CITY of NOVI CITY COUNCIL

Agenda Item 1
April 22, 2014

SUBJECT: Consideration for tentative approval of the request of Edward Rose and Sons for Rose Senior Living at Providence JSP13-81, for a Planned Suburban Low-Rise (PSLR) Overlay Development Agreement Application and Concept Plan. The subject property is 23.61 acres in Section 17 of the City of Novi and located on the north side of Eleven Mile Road and west of Beck Road. The applicant is proposing a 182 unit senior living facility.

SHEET TITLE
BICYCLE AND PEDESTRIAN MASTER PLAN
MRC JOB NO: 20130948 SCALE: AS SHOWN
DATE: MARCH 2014 SHEET: L203
SHEET NO: 30B OF 44

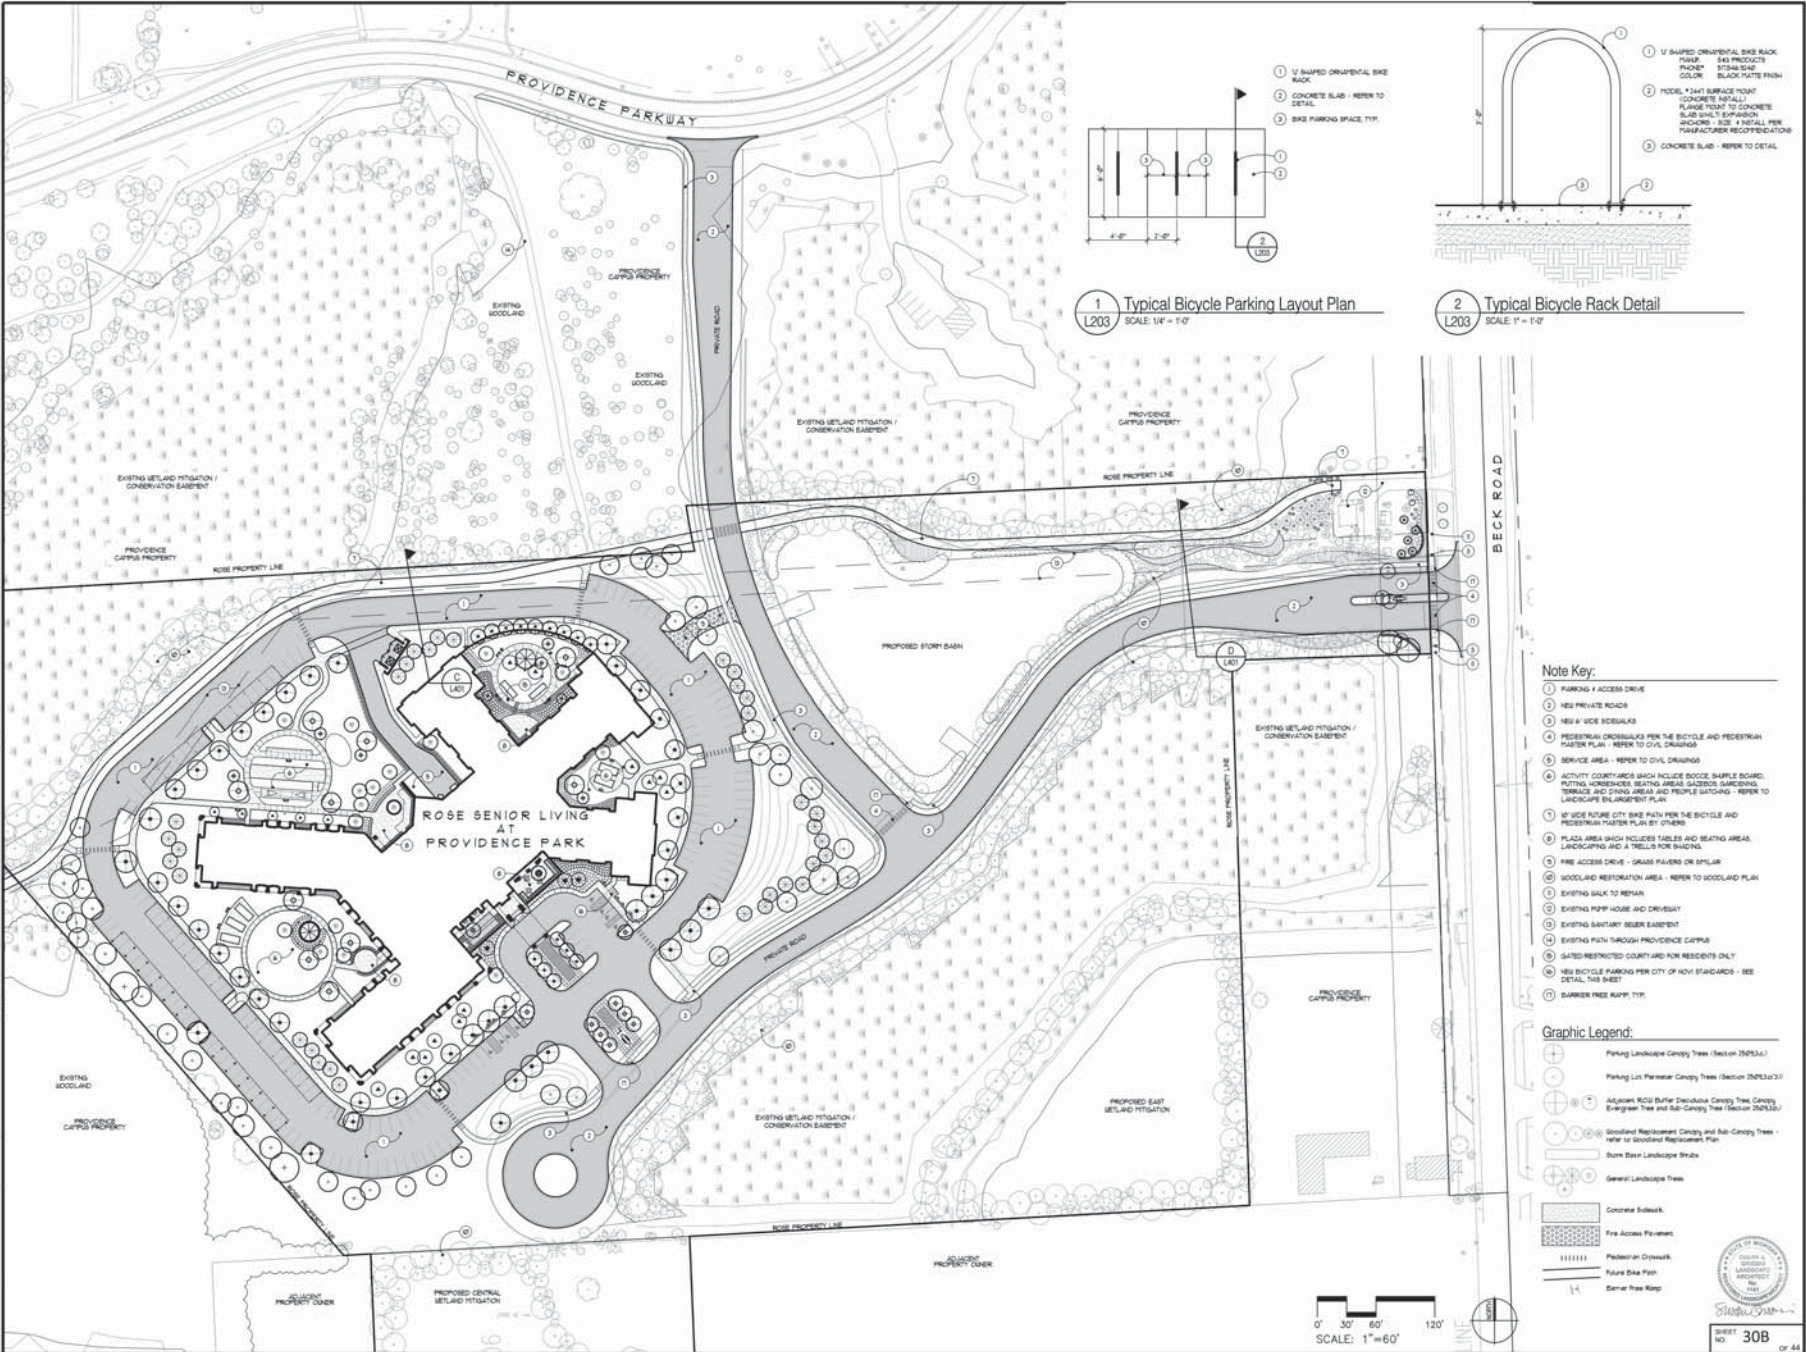
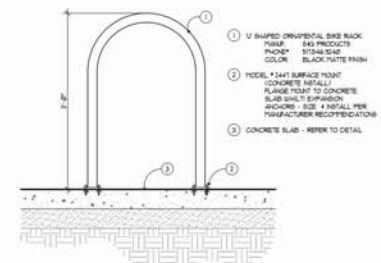
Response: The layout and details for the bicycle parking have been provided on the Bicycle and Pedestrian Master Plan, sheet L203. This sheet has been provided on the compact disc for reference.

<p>Response: A bicycle parking layout and detail have been provided on the Bicycle and Pedestrian Master Plan, Sheet L203. This sheet has been provided on the compact disc for your reference.</p>

FIGURE 1A: PROPOSE 471 FEET OF BUILDING LENGTH THAT EXCEEDS THE 180 FEET MAXIMUM BUILDING LENGTH.

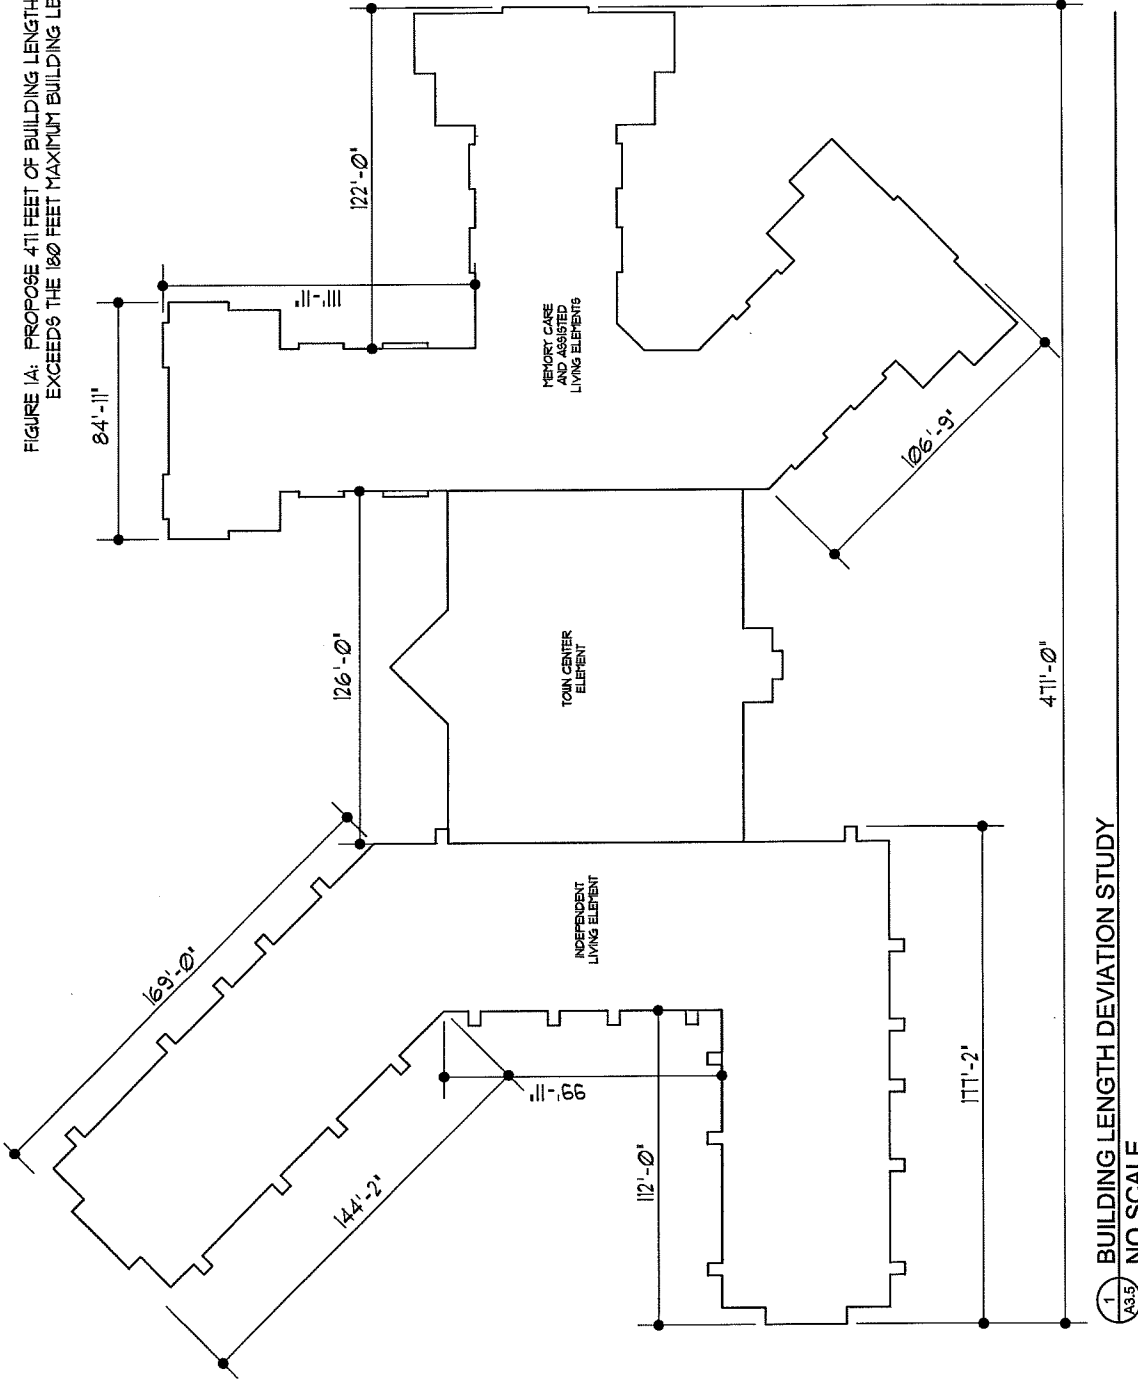
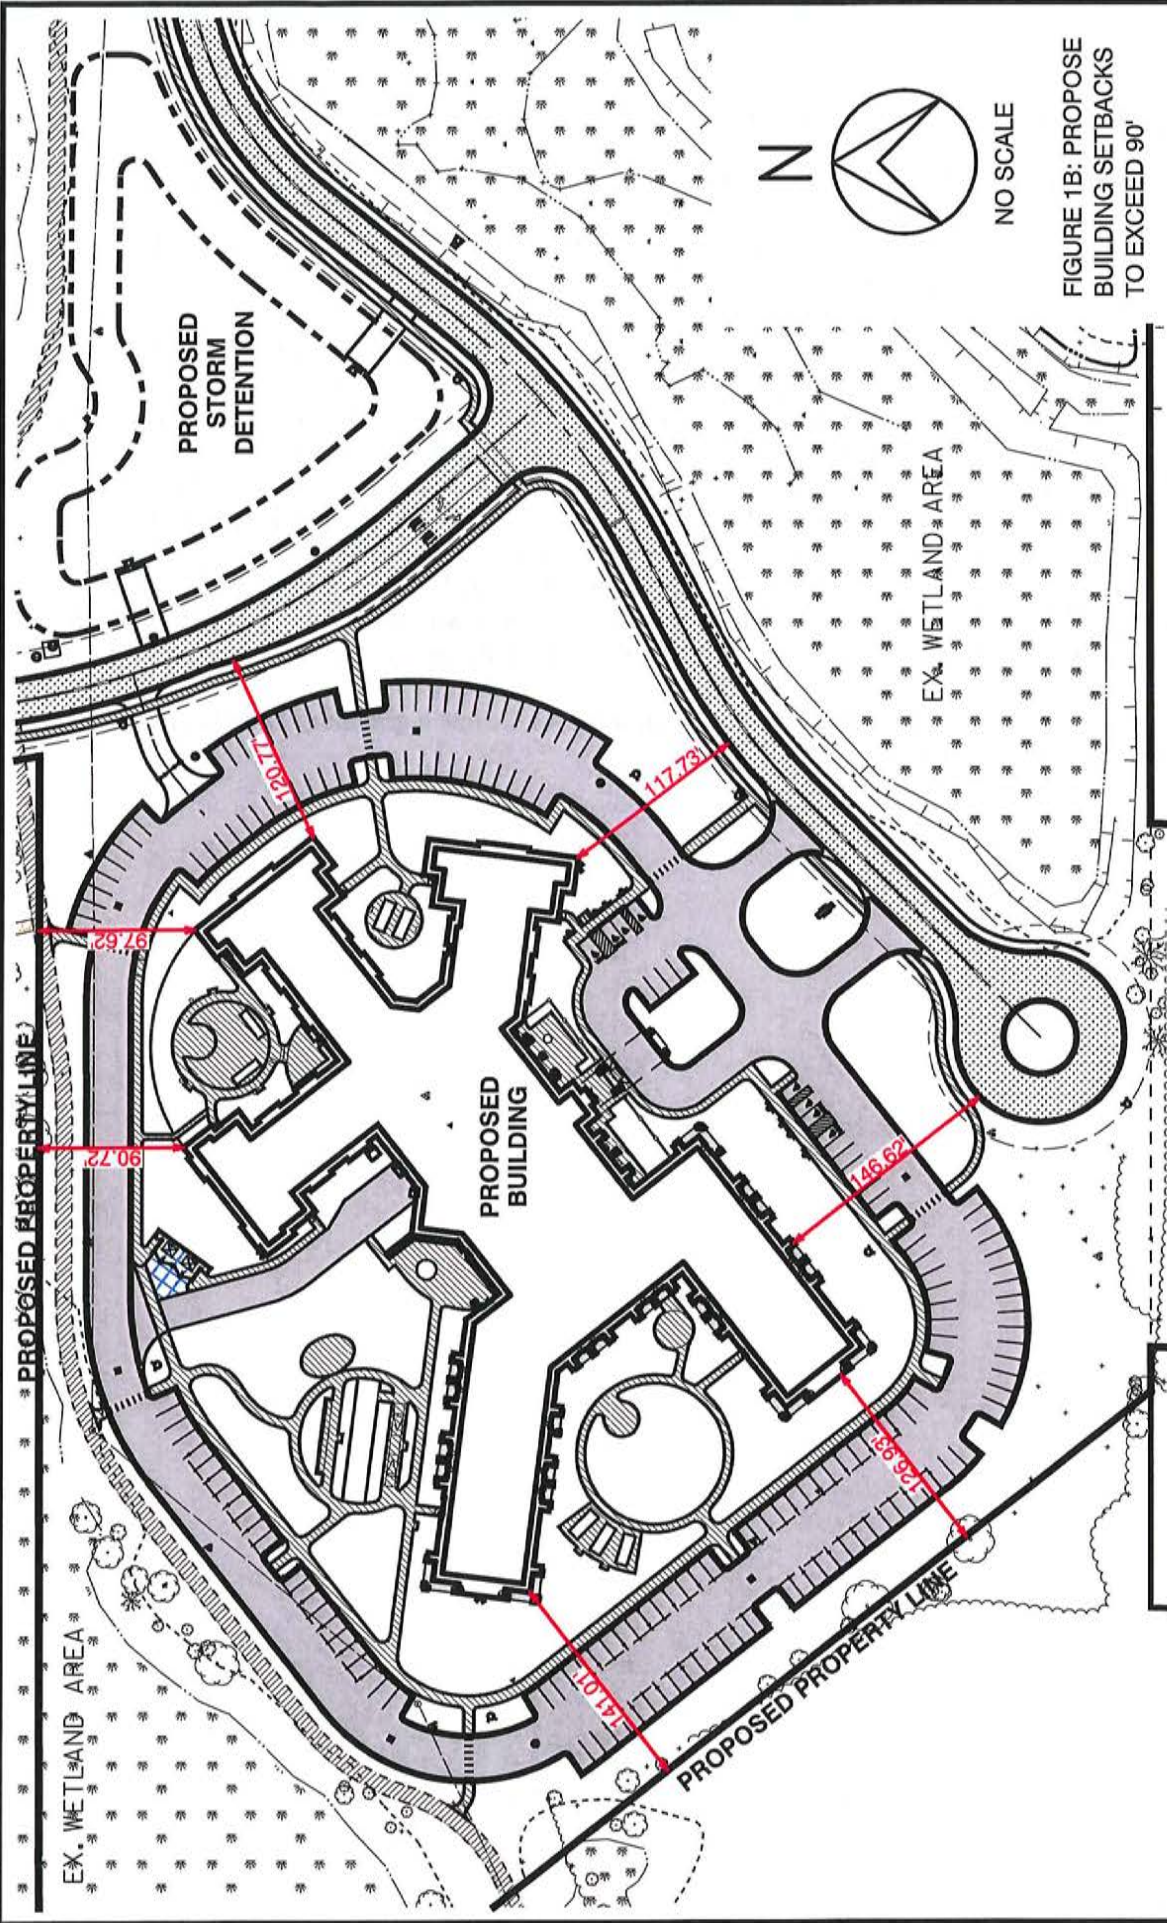
Narrative: The proposed building length is a function of the need to organize all levels of care around a town center. The connected community is made up of four elements, independent living/congregate care, assisted living, and memory care closely connected to the town center to allow the senior residents close and easy access to the building’s amenities. This connection is essential to the success of creating a sense of home, community, and operational efficiency, but can only be done through the design of a building with a longer overall length. We have gone to great measures to “break up” the facades of the building to appear as 4 separate residential elements as opposed to one long straight facade. There is no straight portion of the facade longer than 178 feet.

Graphic Depiction: Figure 1 attached and detail 1 on sheet A3.5 show dimensions of the varying building façade lengths. The proposed building setbacks are shown on Figure 1B attached and on plan sheet C 02.

FIGURE 2: PROPOSE A BUILDING HEIGHT OF 40'-9 1/2" THAT EXCEEDS THE 35 FEET MAXIMUM BUILDING HEIGHT.

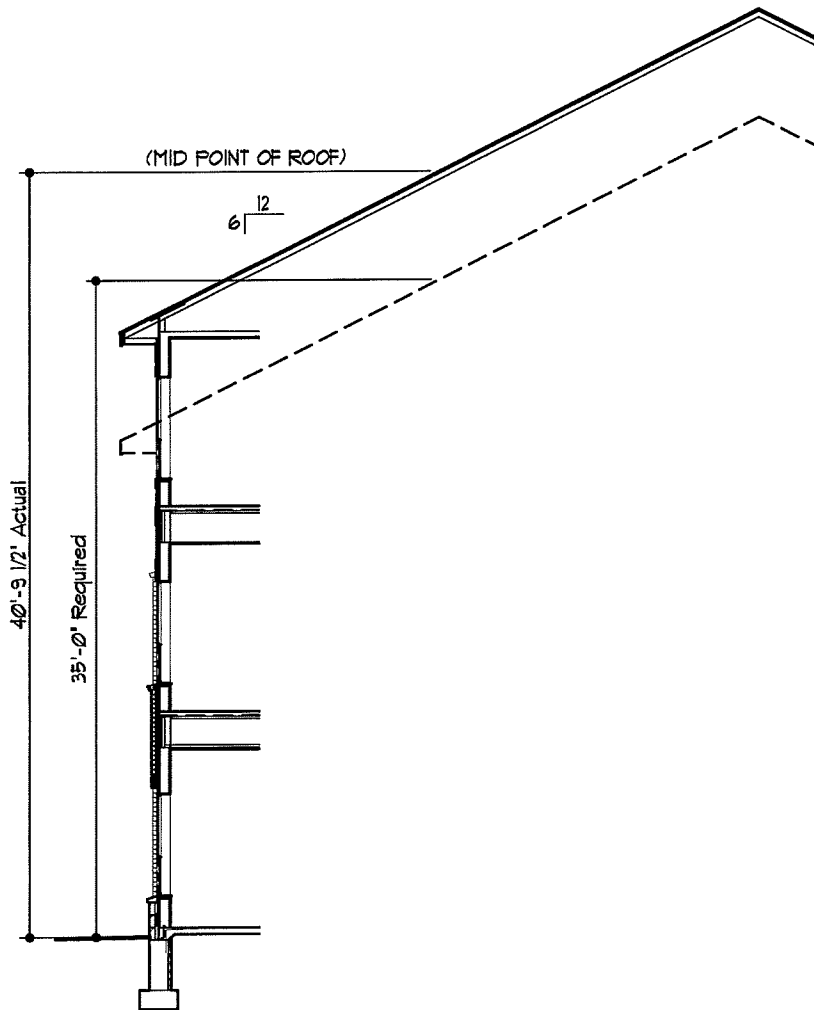
Narrative: The number of units is critical to the operational success of a community that includes the scale of building common areas, landscaped outdoor recreational amenities, natural features, and site improvements that the proposed development provides. Due to the configuration of the existing natural features (woodlands, wetlands, wetland mitigation and associated conservation easements) surrounding the proposed building, a practical difficulty exists to provide the number of units and associated improvements while minimizing impacts to natural features by minimizing the building footprint. If designed as a 2-story building, the proposed building would have a much larger footprint and would disturb 2.5 additional acres of the natural features. The height of the building is also largely a function of the need to get the resident living areas as close as possible to the town center areas and to limit the travel distances, which are critical to the less ambulatory senior's mobility and accessibility.

Graphic Depiction: Figure 2 attached and detail 5 on sheet A3.5 show a graphical depiction of the building height with dimensions.

FIGURE 3: PROPOSE GROUND FLOOR PEDESTRIAN ENTRANCE SPACING GREATER THAN 60 FEET APART ON A PORTION OF THE BUILDING

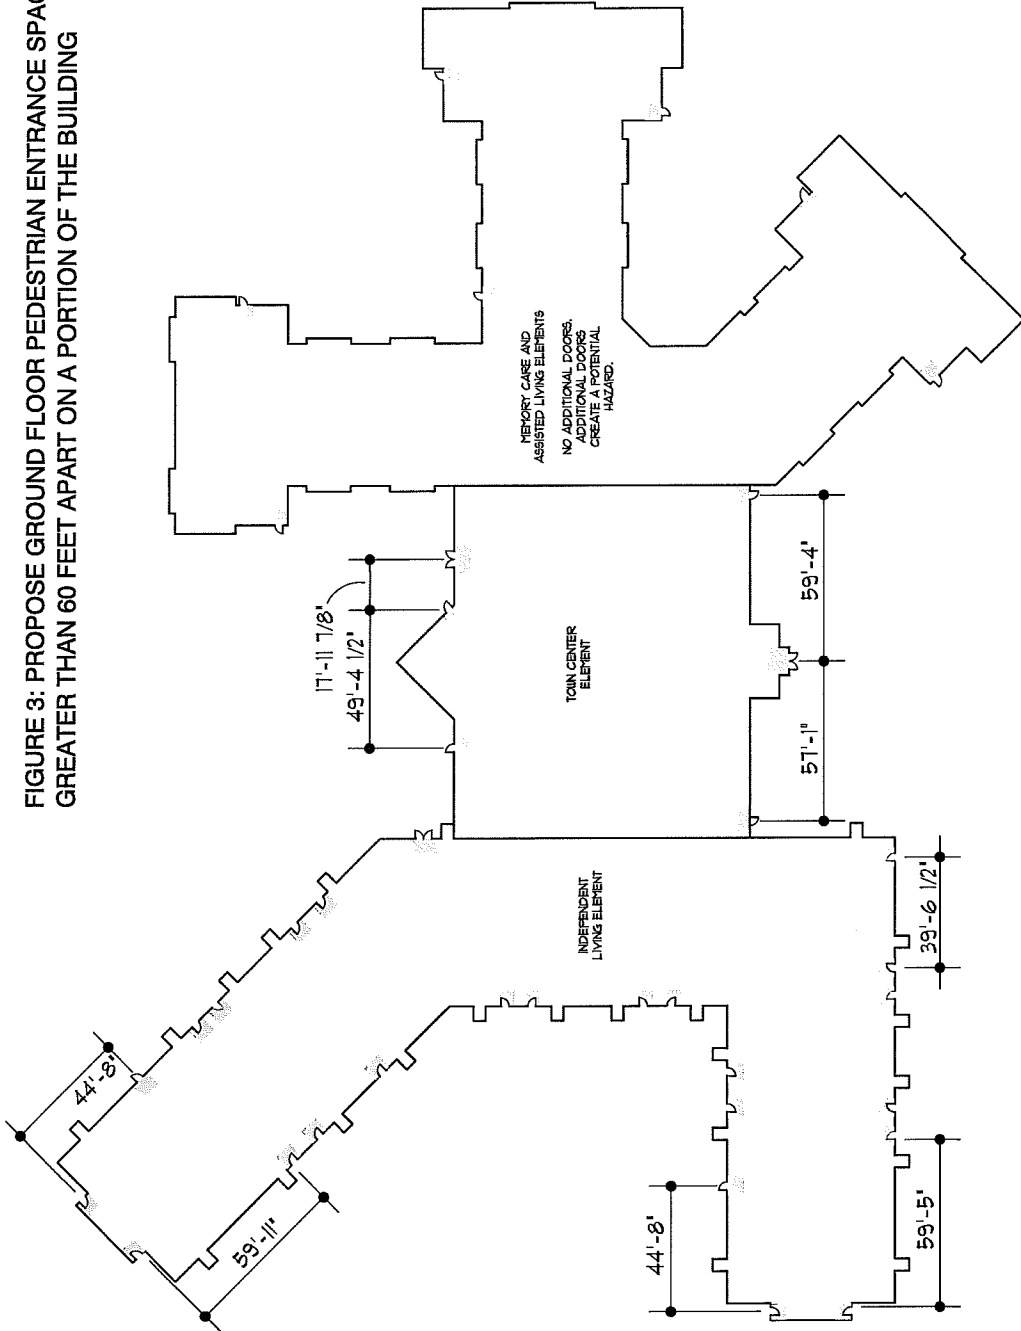
Narrative: The proposed building does have exterior patio doors spaced less than 60 feet apart for the more Independent seniors so a portion of the building meets the intent of the ordinance in that regard. The remainder of the building on first floor is a “neighborhood” specifically for the seniors who need the safety and support of a secured environment (assisted living and memory care); therefore, there are a limited number of controlled access doors spaced greater than 60 feet apart in this portion of the building. Also, it is imperative that the memory care neighborhood occur on the first floor to give the residents the ability to safely enjoy the outdoors in a secured and supervised garden designed specifically for individuals with Alzheimer’s and tendencies to wander.

Graphic Depiction: Figure 3 attached and detail 6 on sheet A3.5 show a graphical depiction of the ground floor pedestrian entrance spacing.

FIGURE 5: PROPOSE
PARKING IN THE FRONT
YARD (SOUTH) AND
EXTERIOR SIDE YARD
(EAST)

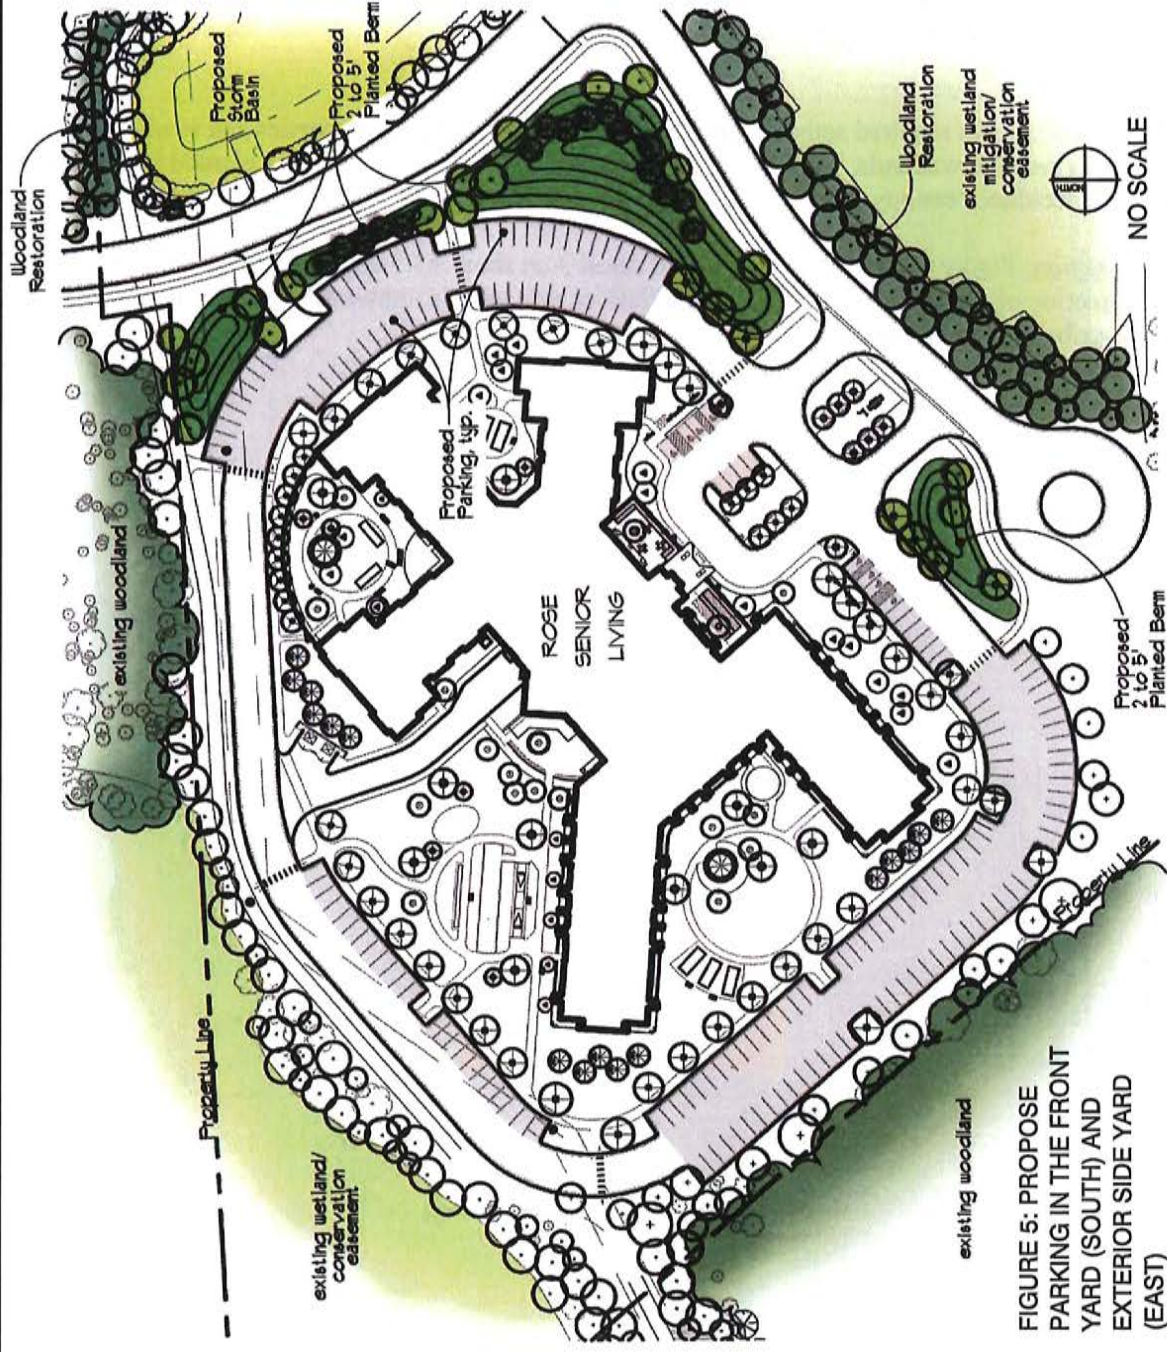
Narrative: Due to the configuration of the existing natural features (woodlands, wetlands, wetland mitigation and associated conservation easements) surrounding the proposed building, a practical difficulty exists to provide parking within the rear and interior side yard setbacks. The deviation is requested to minimize impacts to existing wetlands and natural features. The proposed undulating planted berm, heavily planted parking lot perimeter, existing natural features, proposed restoration of woodlands/wetlands, and generous distance from public roads effectively buffers and screens these parking spaces from proposed roads and from adjacent existing roads (e.g. 11 mile and Beck Rd.) Also, the parking spaces for the senior residents are provided around the perimeter of the building to minimize walking distances from pedestrian doors to the parking spaces.

Graphic Depiction: Figure 5 attached and plan sheet L201 show a graphical depiction of the off-street parking proposed in the front yard (southeast) and exterior side yard (northeast) illustrate the elements described in the narrative.
